UNITED STATES
NUCLEAR REGULATORY COMMISSION

SUBJECT: FEBRUARY 6-7, 2003, MEETING SUMMARY: MEETING WITH DUKE
COGEMA STONE & WEBSTER TO DISCUSS MIXED OXIDE FUEL
FABRICATION FACILITY REVISED CONSTRUCTION
AUTHORIZATION REPORT

**MEETING SUMMARY
MOX FUEL FABRICATION FACILITY
February 6-7, 2003**

Plutonium (VI) Analysis

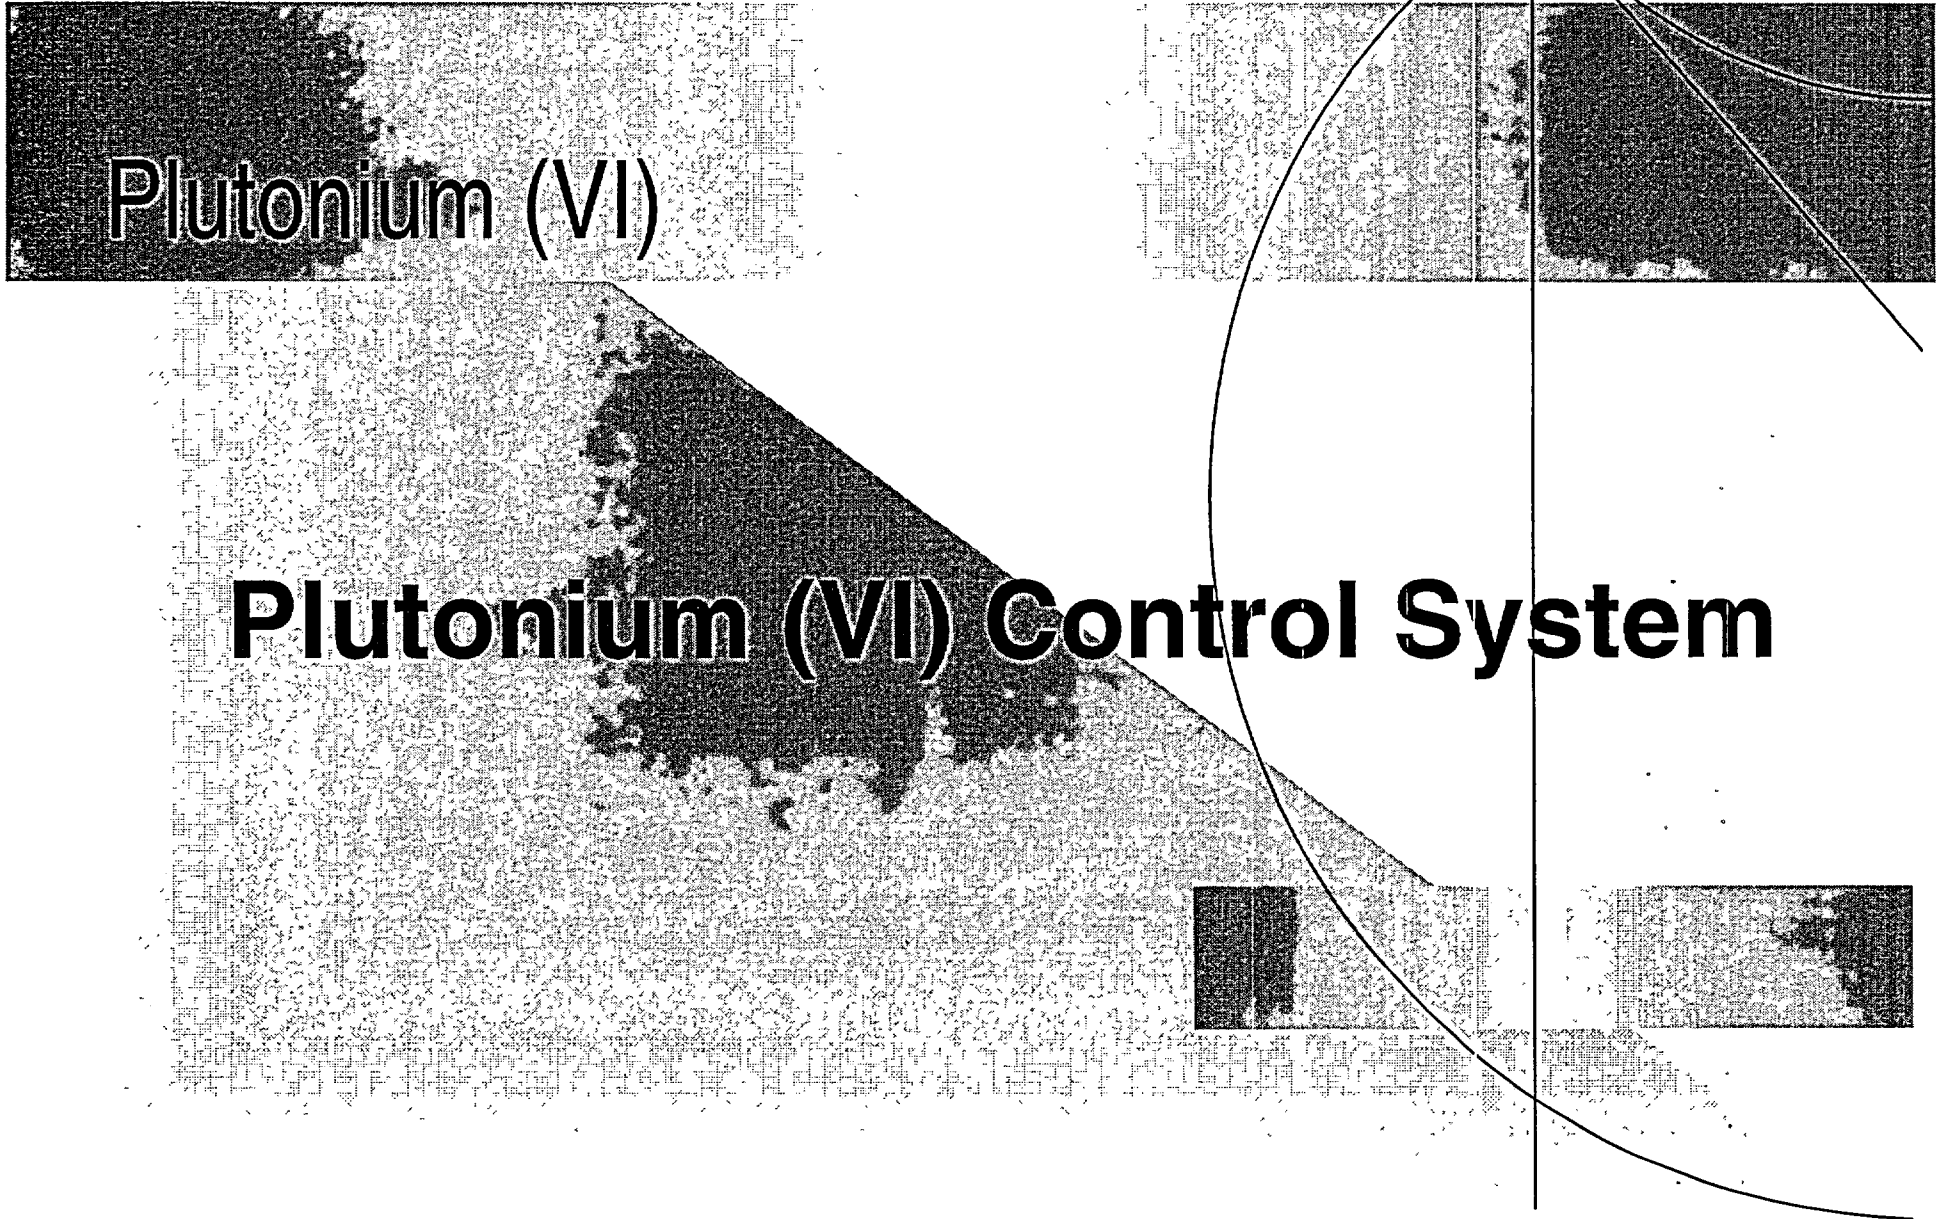
2. Pu(VI) Control System (AP-14)

The purification process is to prevent the introduction of Pu(VI) into the oxalic precipitation unit (furnace) through: valence state measurements of Pu; limiting the maximum Pu(VI) content (TBD); and developing a method to detect Pu(VI) as part of the final design process. DCS pointed out that methods under consideration included ultraviolet-visible spectrum (1E-5 resolution M) and alpha-spec (1E-9m resolution), as part of the sampling technique validation process. The sampling measurements would occur before the oxalate could be formed.

- ◆ The maximum quantity of Pu(VI) acceptable will be determined during the ISA using the methodology as described in the December 10-12 meeting.
- ◆ Appropriate Pu(VI) Detection Systems will be implemented, some possible analytical instruments are:
 - ✓ UV-Vis. spectroscopy: resolution to 10^{-5} M
 - ✓ α -spectroscopy: resolution to 10^{-9} M

EFFECT OF Acid composition on the Pyrophoric Reaction with Unalloyed Titanium in Red Fuming Nitric Acid

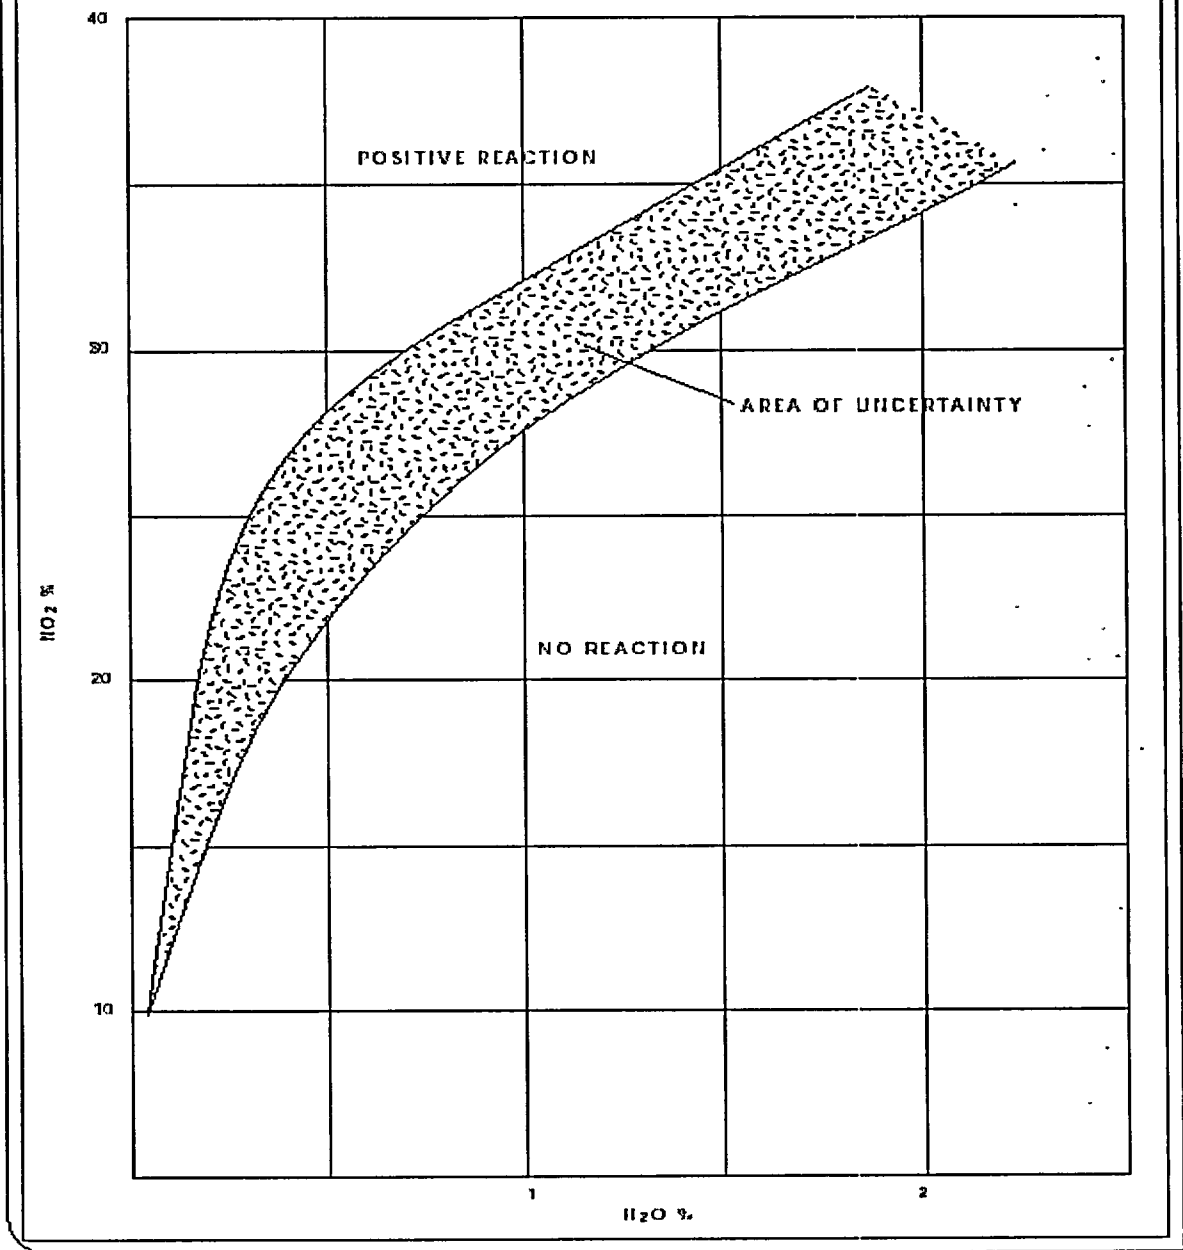
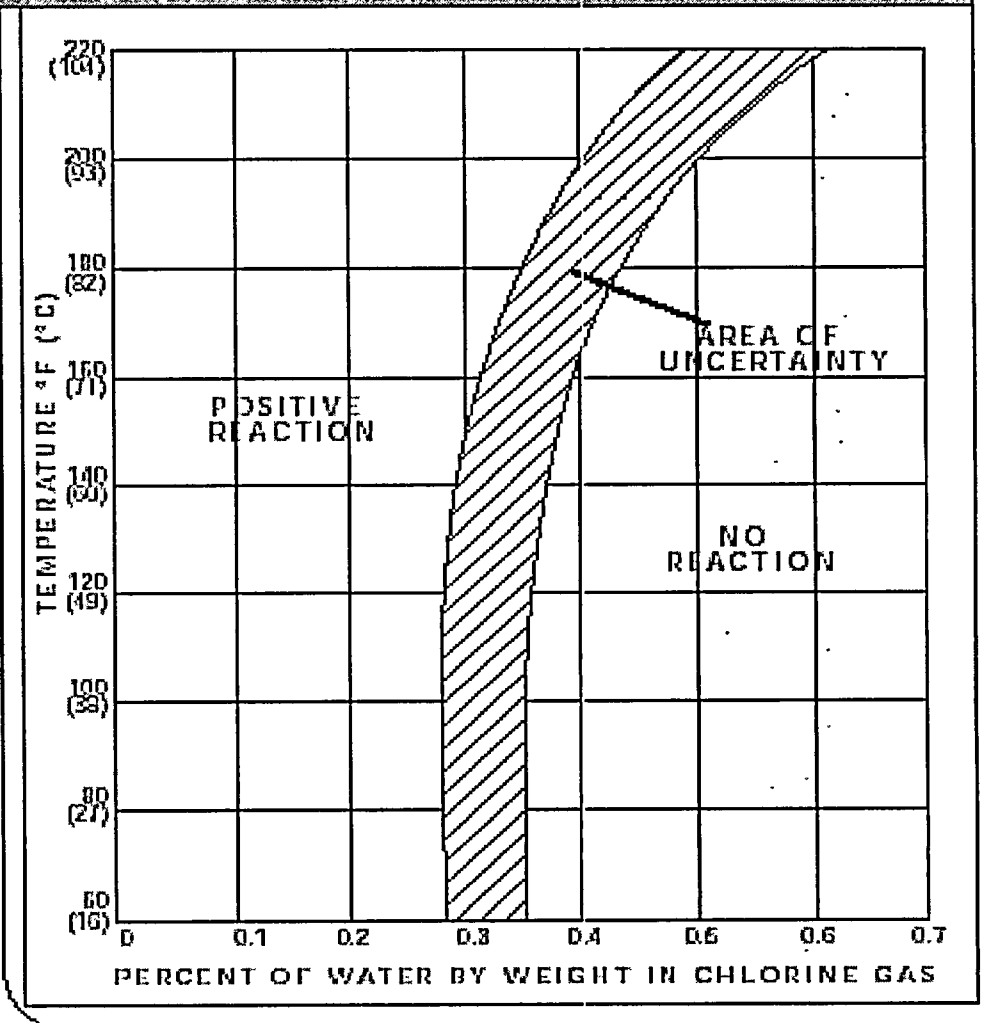
3. Titanium (Ti): Prevention of Ti Fires (AP-03)

DCS agreed to provide an analysis of an electrolyzer failure (ground faults, etc.) as the initiator of a titanium fire for thick components (>1/30 inch). Any electrical protection schemes would be identified, if needed. DCS also noted that for thin walled components, inter-granular stress corrosion cracking (IGSC) played a major part. For this failure mechanism, NO₂ (from HNO₃ - Ti reaction) was the major contributor. By adding more water, the reaction is forced back. DCS agreed to provide operating history information on IGSC of Ti components in similar facilities and additional information that demonstrates the adequacy of the DCS glovebox fire strategy for fires involving bulk Ti (thermite reaction).

- ◆ Administrative control to limit normality of nitric acid which inhibits the NO_2 inter-granular corrosion.
- ◆ Calculation will be performed during the ISA to ensure that the energy available due to the electrolyzer is not sufficient to cause titanium fire given the thickness of the electrolyzer.
